Cannon Beach Planning Commission

Staff Report Addendum (10:00 AM February 24, 2022)

PUBLIC HEARING AND CONSIDERATION OF **AA 22-01**, GREG HATHAWAY'S, ON BEHALF OF JEFF AND JENNIFER HARRISON, APPEAL OF THE CITY'S ADMINISTRATIVE APPROVAL OF A BUILDING/DEVELOPMENT PERMIT FOR 534 NORTH LAUREL STREET. THE PROPERTY IS LOCATED AT 544 N. LAUREL STREET (TAX LOT 07002, MAP 51019AD), AND IN A RESIDENTIAL MEDIUM DENSITY (R2) ZONE. THE REQUEST WILL BE REVIEWED PURSUANT TO MUNICIPAL CODE, SECTION 17.88.180, REVIEW CONSISTING OF ADDITIONAL EVIDENCE OR DE NOVO REVIEW AND APPLICABLE SECTIONS OF THE ZONING ORDINANCE, CONDITIONS OF APPROVAL OF THE CANNON BEACH PRESERVATION PLANNED DEVELOPMENT SUBDIVISION AND APPROVED PLAT.

Prepared By: Jeffrey S. Adams, PhD

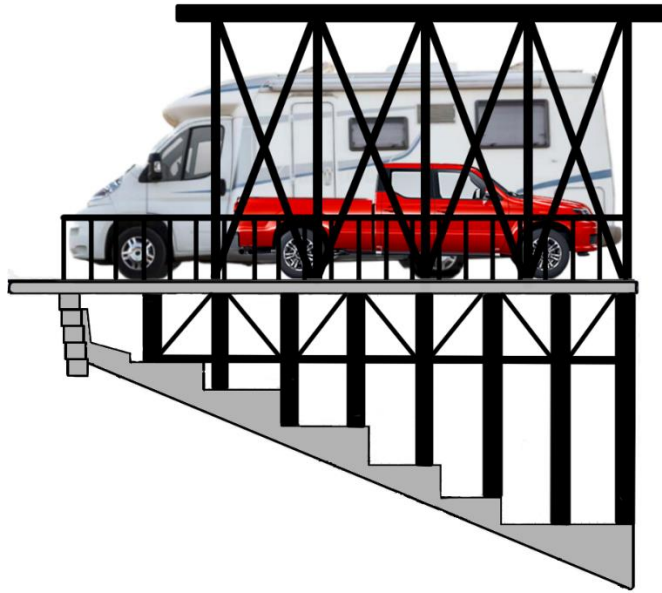
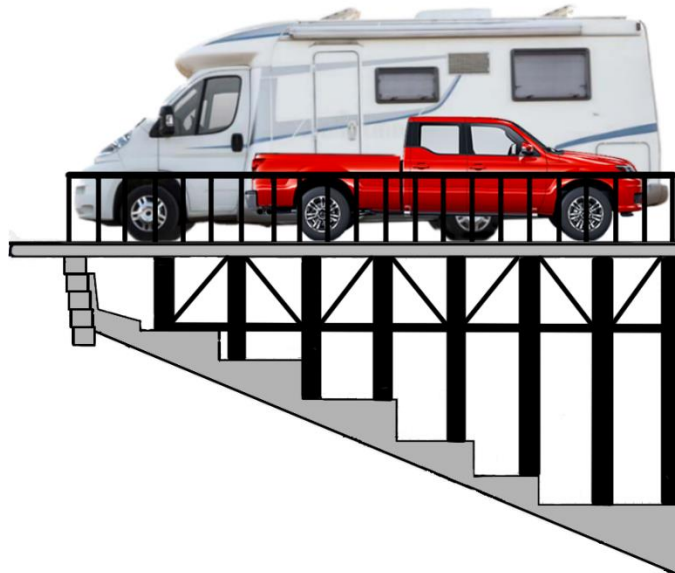
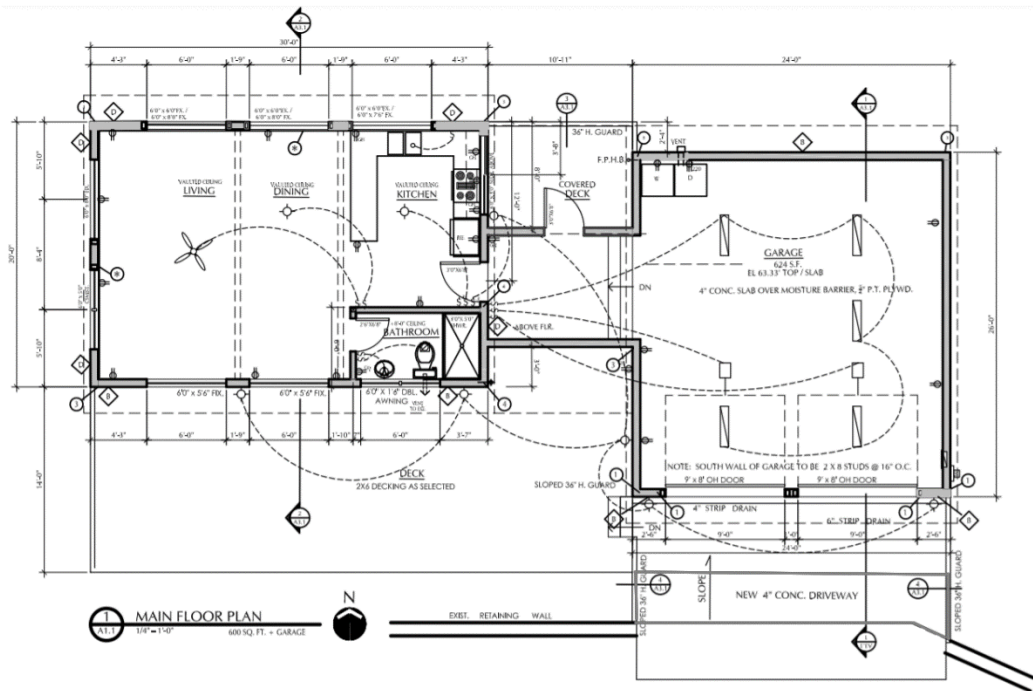
If on the other hand you determine that the purpose of Condition 16 was to encourage the lot owners to build detached garages only on the flattest portions of their property, then you are implicitly deciding that a detached garage on sloping ground is less desirable than a carport in the same location, which is not covered by the restriction against a second story. You’re also deciding that a detached garage on sloping ground, such as one which when viewed from the east would look like this:

is less in keeping with the planned development than a carport such as this one, which when viewed from the east would look like this:

as well as an open-air parking deck, which is neither a garage or a carport and not restricted by Condition 16 at all.
